**The Scottish Government
Energy Consents Unit**

**Scoping Opinion On Behalf Of Scottish Ministers Under The
Electricity Works (Environmental Impact Assessment) (Scotland)
Regulations 2017**

**Creag Dhubh to Dalmally 275kV Connection
Scottish Hydro Electric Transmission PLC**

8 March 2022

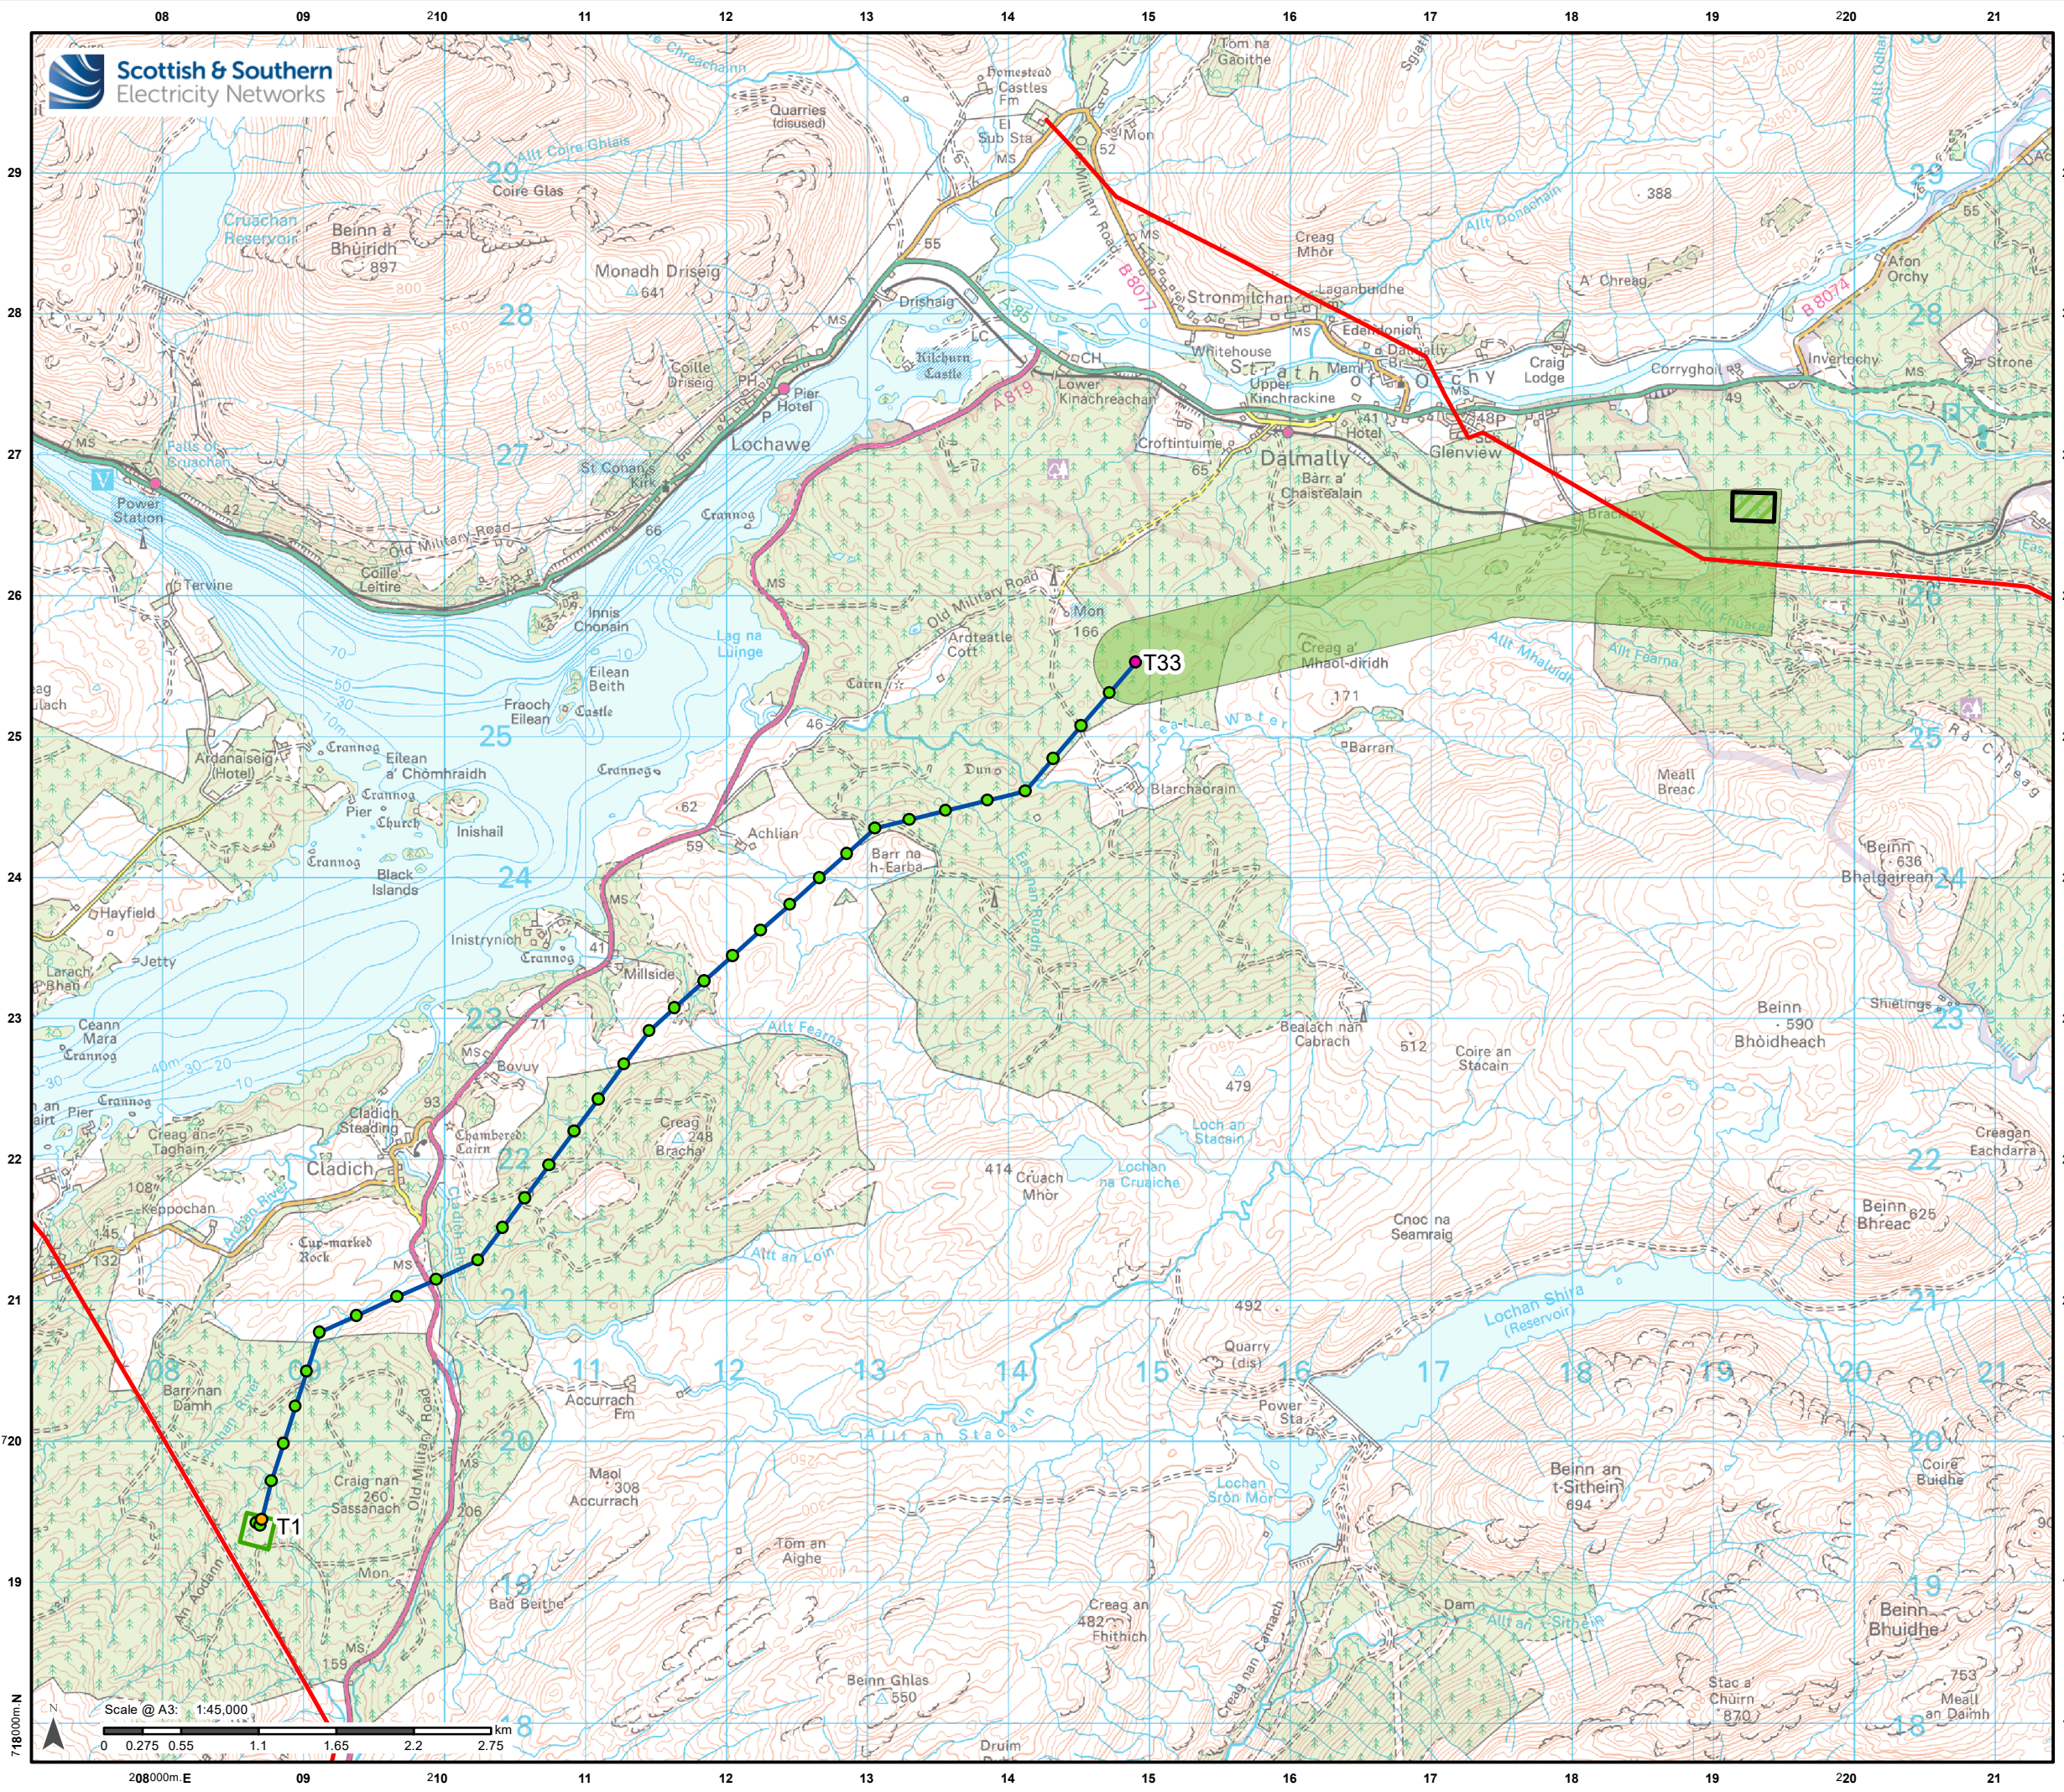
We have studied the Locations of the Tower Structures for Creag Dhubh to Dalmally 275 kV Connection proposal with respect to EMC and related problems to BT point-to-point microwave radio links.

We have assumed a maximum Tower Height of 60m as indicated in section '2.4 Indicative Overhead Line Design' of the scoping report. Tower Number 18 runs directly under BT Radio Link 6140 from DALMALLY POLICE SITE to KILCHRENAN TE. If these Tower heights increase above 60m you will need to resubmit your proposal and BT will reassess the impact accordingly.

With the Tower Height at 60m the conclusion is that, the Project indicated should not cause interference to BT's current and presently planned radio network.
